STAFF REPORT: 2/17/2021 MEETING PREPARED BY: D. RIEDEN

APPLICATION NUMBER: #21-7051 ADDRESS: 1531 EIGHTH STREET HISTORIC DISTRICT: CORKTOWN

SCOPE: PORCH/DECK, FENCE/GATES, GENERAL REPAIR

FRONT PORCHES ELEVATIONS AND SECTIONS

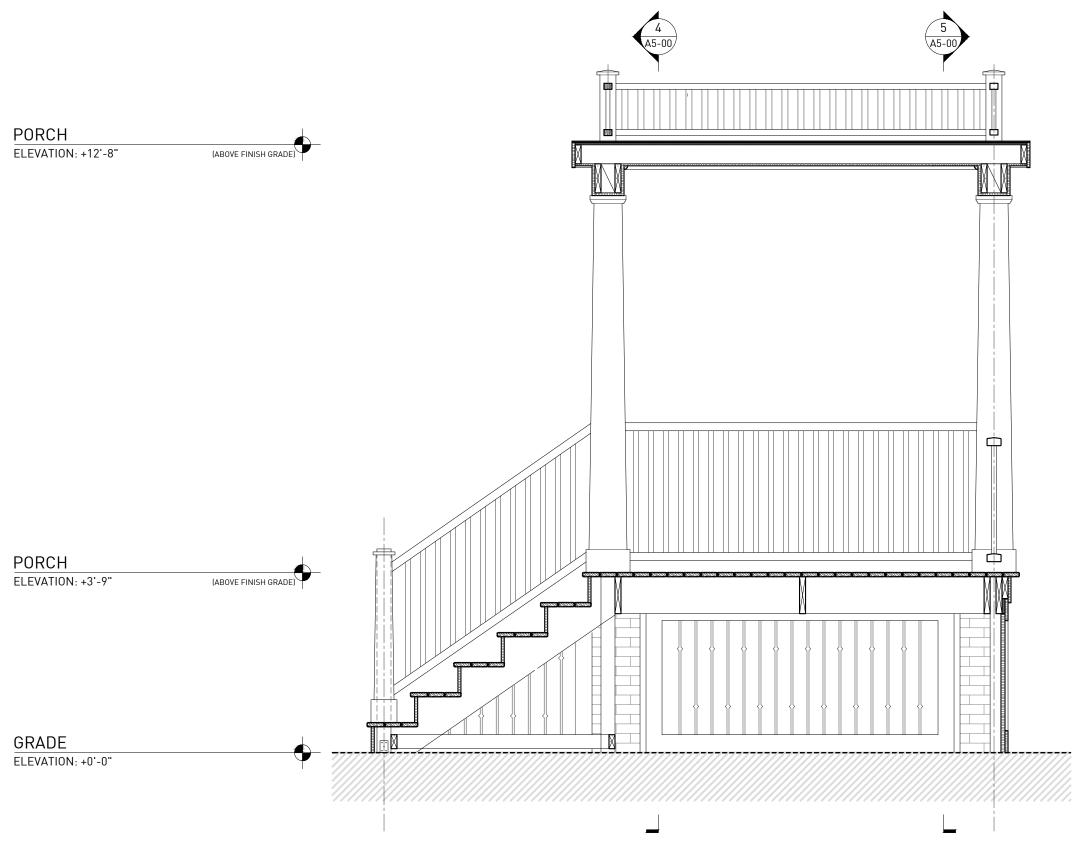
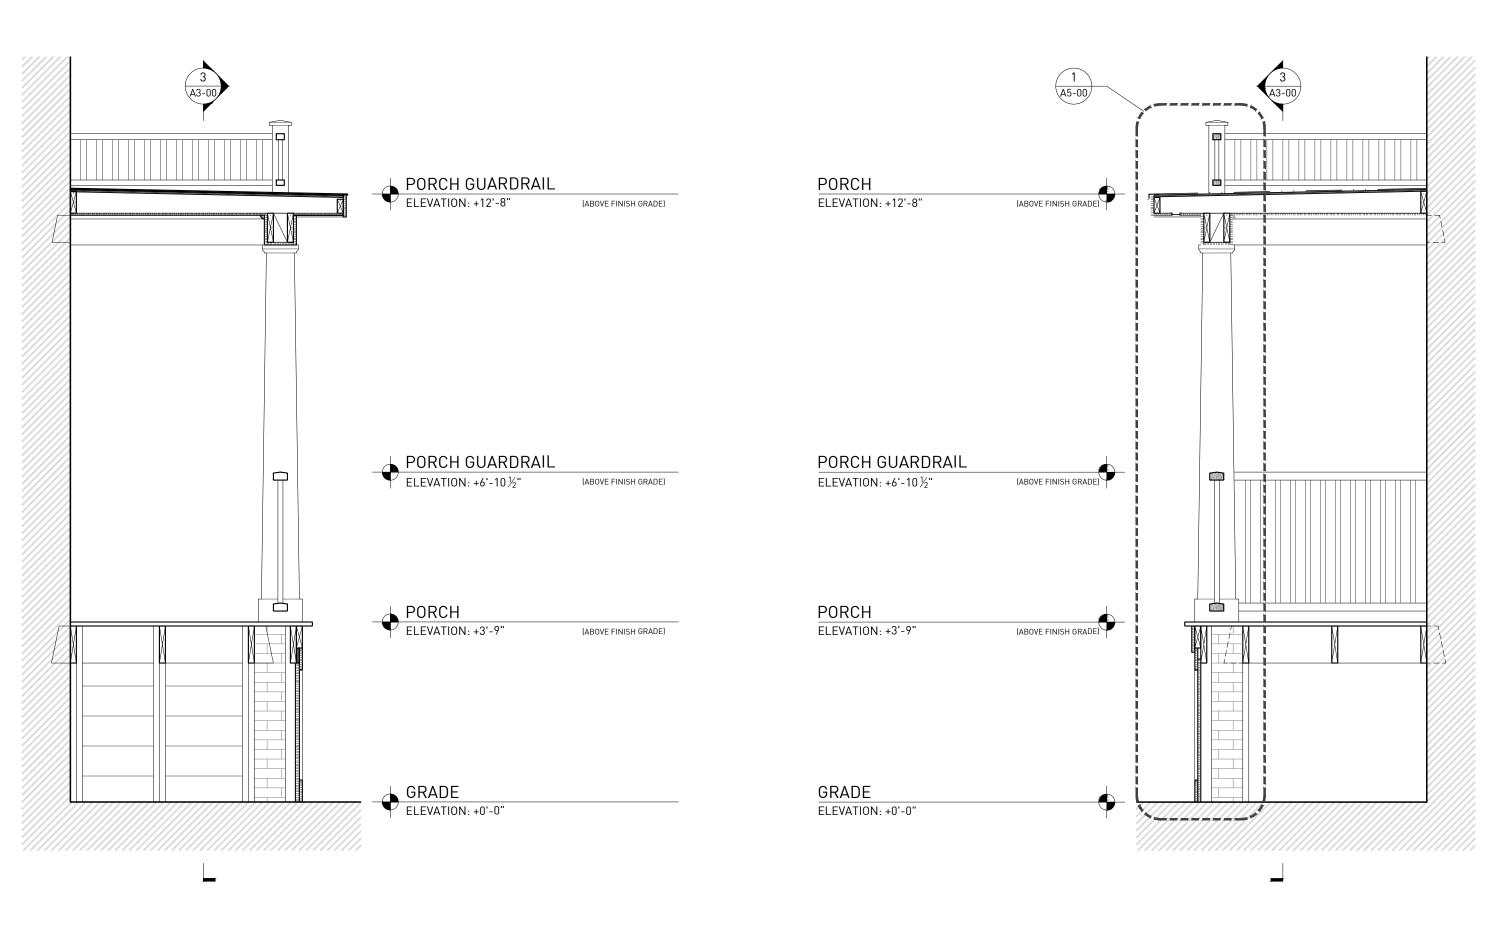
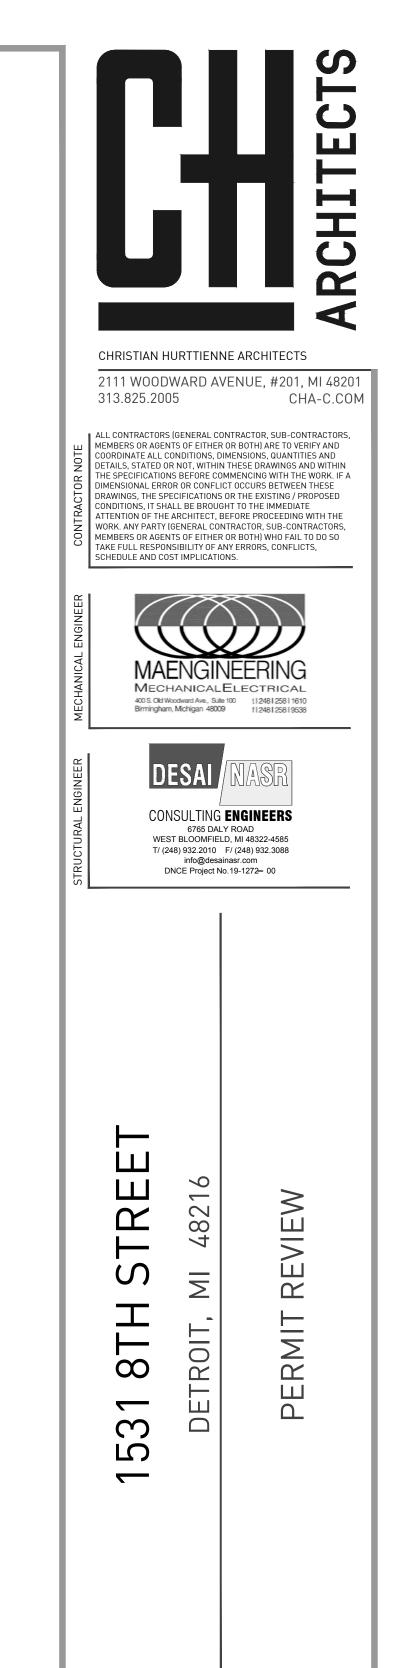
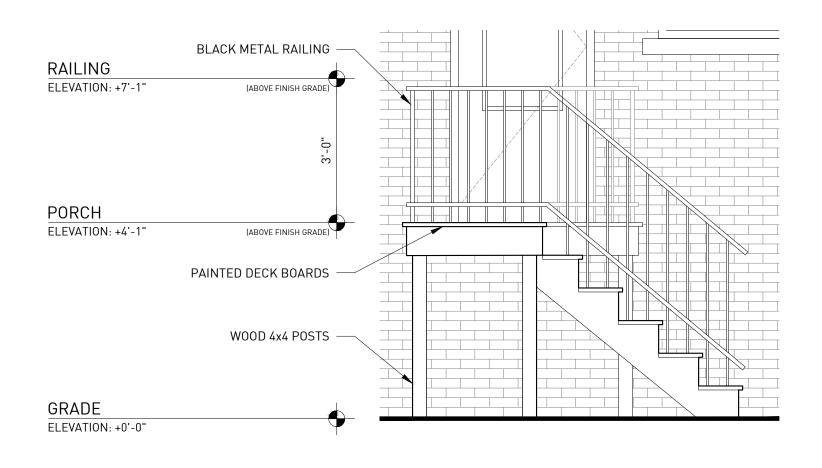
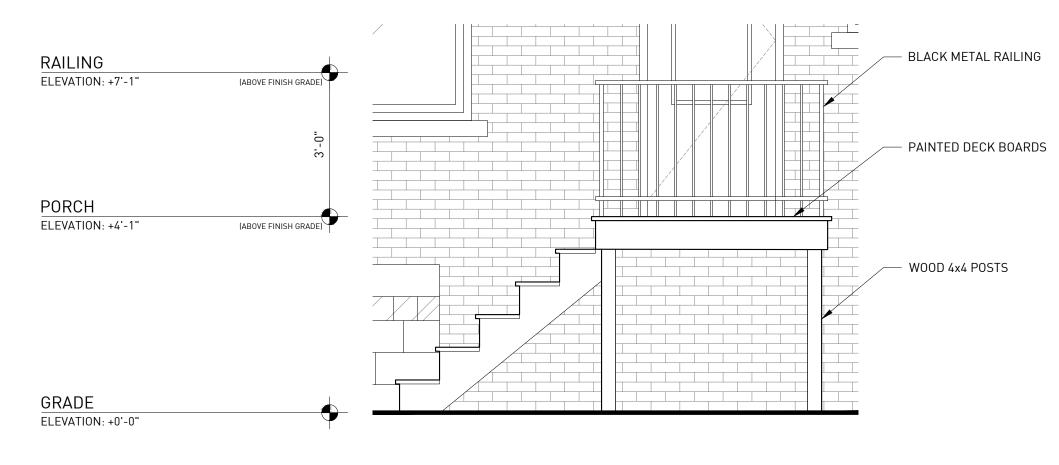
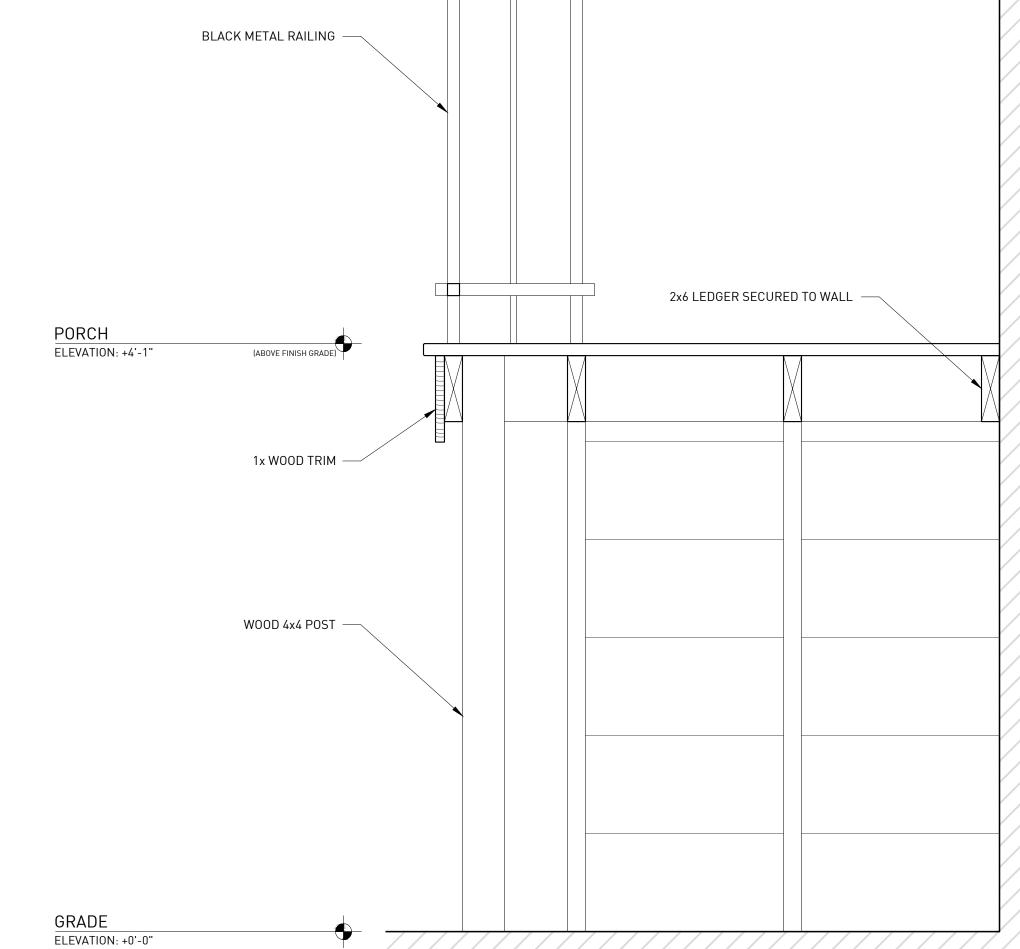
• Staff identifies that the front porches are distinctive character-defining features of the property. Though field investigation and analysis have identified historic elements, other elements (to include the flooring and railing) are later non-significant replacements. The observed displacement in several elements indicates that the floor and support structure has degraded, suggesting that all three porches need to be rebuilt as they are deteriorated beyond repair. However, the three roofs, including their associated trim pieces and beadboard

ceilings should be stabilized/restored in place, while the areas below are replaced-in-kind. The porches' wood columns and other historic-age salvageable elements, should also be re-used to the greatest extent feasible. The roof and columns are character defining elements of the front porches and are identified in the Elements of Design of the Corktown Historic District:

- The applicant maintain the three front porches' wood columns and roofs, including their associated trim pieces and beadboard ceilings. The applicant shall provide HDC Staff with the final drawings to verify they meet this condition. Staff shall receive the opportunity to review and approve this submission prior to the issuance of the permit.
- The applicant shall provide HDC Staff with the final paint selection to verify they meet with Historic District Color Guide, Color Scheme C. Staff shall receive the opportunity to review and approve this submission prior to the issuance of the permit.
